ADDENDUM 2 TO WEST GATE TUNNEL PROJECT TRANSPORT EVIDENCE STATEMENT - MATTER 21701517 – RESPONSE TO SUBMISSIONS ON BEHALF OF VICROADS

Dohertys Road

Figure 5: Potential west facing ramps at Dohertys Road to/from M1

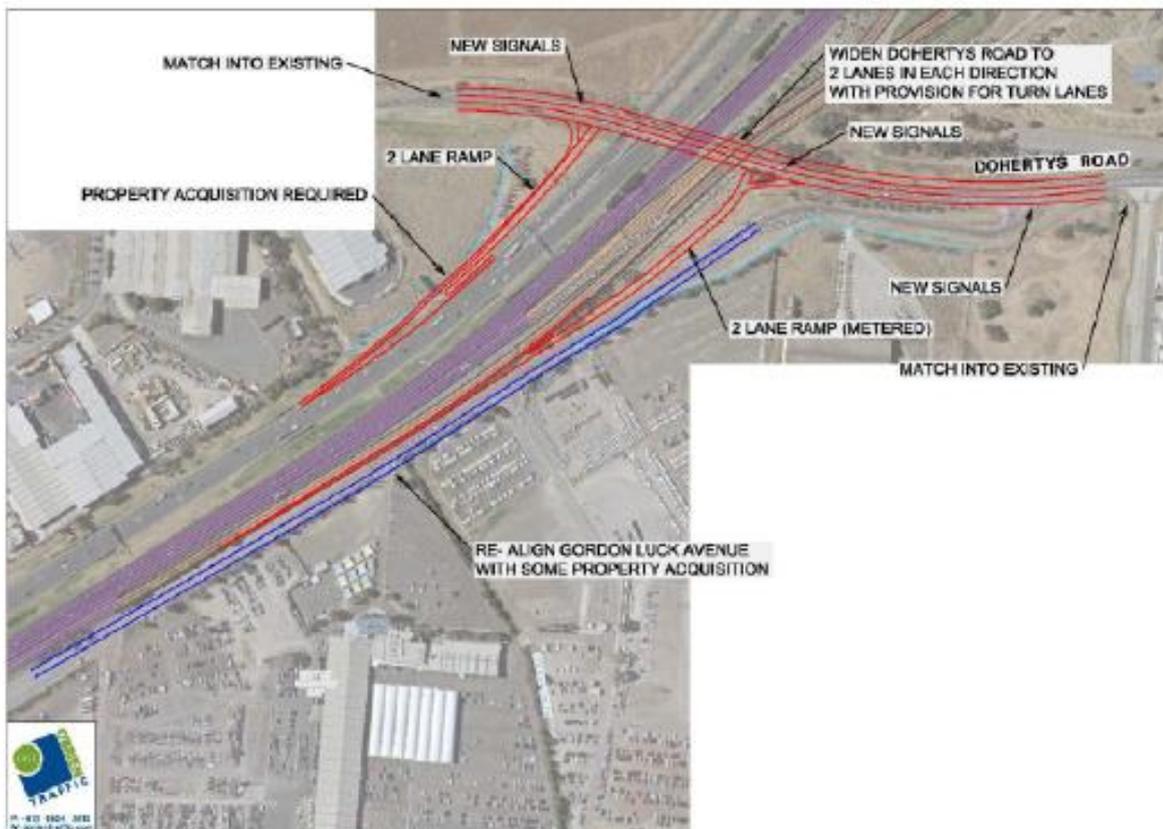
98 As with the ramps proposed at Grieve Parade, VicRoads' position is that the IAC should not make any recommendation for further consideration of ramps at Dohertys Road. Any ramps constructed at Dohertys Road would conflict with proposed or modified ramp connections from the Project and M80 and cannot be incorporated, either safely or efficiently. Any connection between the M80 and Dohertys Road (to the north) would be physically constrained by reason of the braided connections with the M80, West Gate Freeway, Princes Freeway West and proposed Project interchange areas”.

The submission continues: “99 These connections would only further complicate the merging, diverging and weaving movements required by vehicles in the area, and would jeopardise the performance of the relevant motorway section. This is particularly concerning given that the relevant motorway section is immediately downstream of three connections coming together”

101 Having regard to Mr O’Brien’s suggested figure, VicRoads submits that:

- (a) the inclusion of additional ramps would further increase traffic demands by attracting additional trips to the Princes Freeway between Dohertys Road and Kororoit Creek Road, a route which is already sufficiently accommodated by arterial roads (and noting the deleterious effect of introducing short trips into the freeway network);*

- (b) the proposed North-East bound exit ramp creates two exit ramps (one service, one system) in immediate proximity to each other, which is considered to be poor freeway design because it introduces confusion by a lack of clarity around traffic movements and will result in overuse of the left lane(s) of the Princes Freeway on the approach to a critical system junction;*

- (c) the proposed merge location of South-West bound entry ramp is immediately upstream of the main ramp joining the freeway mainline and is, therefore, unsafe. At such a location, drivers on the system ramp connection need to be concentrating on the mainline traffic and adjusting their speed/position to merge safely, not dealing with local traffic movements merging from the left; and*

- (d) further land acquisitions would be necessary to accommodate the ramps, and this is outside the scope of the Project”.*

Regarding “Any ramps constructed at Dohertys Road would conflict with proposed or modified ramp connections from the Project and M80 and cannot be incorporated, either safely or efficiently”, this comment is wrong and cannot be substantiated. Firstly, the proposed ramps do not conflict in any way with the proposed new or modified connections between M1 and M80 – they are to the west of any other connections. The proposed ramps are virtually a mirror image of the Grieve Parade exiting ramps – Grieve Parade is a half diamond interchange facing east and located east of the M80 interchange, and our proposed Dohertys Road ramps are west facing and located t the west of the M80 interchange. There is absolutely no reason that such proposed ramps cannot be operated ‘safely and efficiently’.

The comment under (b) that *“the proposed North-East bound exit ramp creates two exit ramps (one service, one system) in immediate proximity to each other, which is considered to be poor freeway design”* is addressed by our modified proposal to take the off-ramp off a little further to the west. This would result in a perfectly adequate exit ramp spacing.

The comment under (c) that *“the proposed merge location of South-West bound entry ramp is immediately upstream of the main ramp joining the freeway mainline and is, therefore, unsafe”* is interesting – as well as wrong. The minimum acceptable distance from successive merges is about 250 m – i.e. just beyond the completion of the first merge (320 m from the physical nose).

With respect to item (d), if the widening of the westbound mainline took place in the median, the proposed ramp would not require any additional widening to the south of that which is currently proposed by the Project.

FIGURE 1: Modified plan for Dohertys Road west-facing ramps

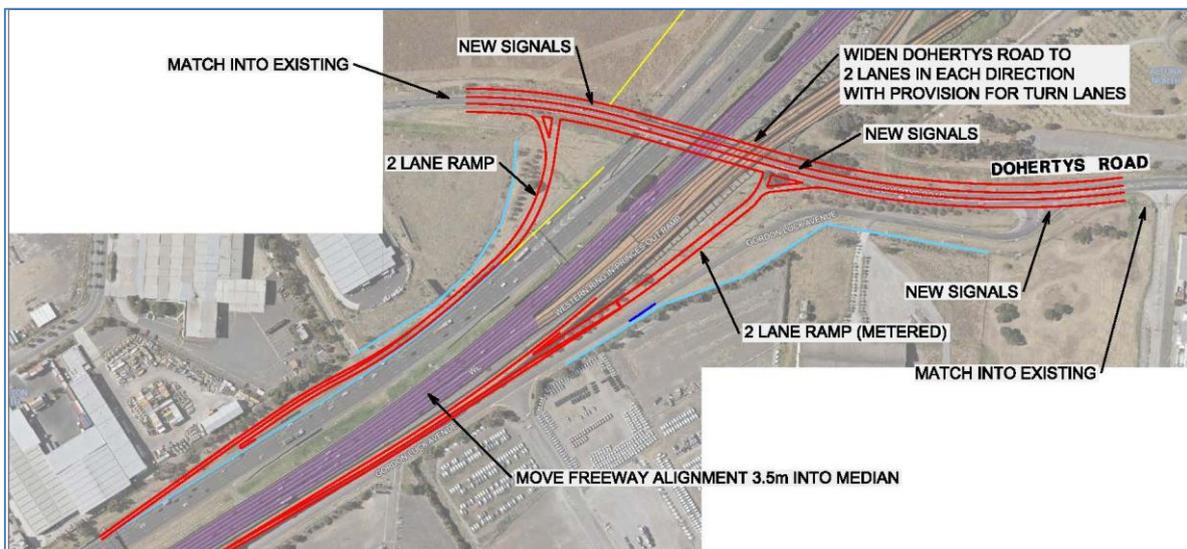
With respect to the off-ramp, O'Brien Traffic has slightly revised the initial sketch to bring the off-ramp nose slightly further to the west – enabling a separation of that ramp and the ramp to M80 of about 300 m. This separation is quite common in modern networks – e.g. Great South Road exit within the SH1/SH20 interchange in Auckland – which operates quite satisfactorily. The westbound off-ramp to Montague Street is only 280 m before the off-ramp to Tullamarine. A diverge is usually not an operational issue. As a general principle, successive exits need to be separated by a minimum of about 250 m to allow for lane changing and to be appropriately signed.

The proposed on-ramp from Dohertys Road is proposed to merge onto the connector from the tunnel to Princes Freeway – with the merge completed before that ramp merges onto the Princes Freeway mainline. The Dohertys Road on-ramp would have ramp metering – so there would be no operational merge issues. The proposed amended plan is shown in **Figure 1**. It addresses VicRoads issues.

The potential weave manoeuvres involved would be between the Kororoit Creek Road ramps and the exit to Dohertys Road, and between the tunnel connection and Kororoit Creek Road. The distances involved are greater than those which require weaving analysis.
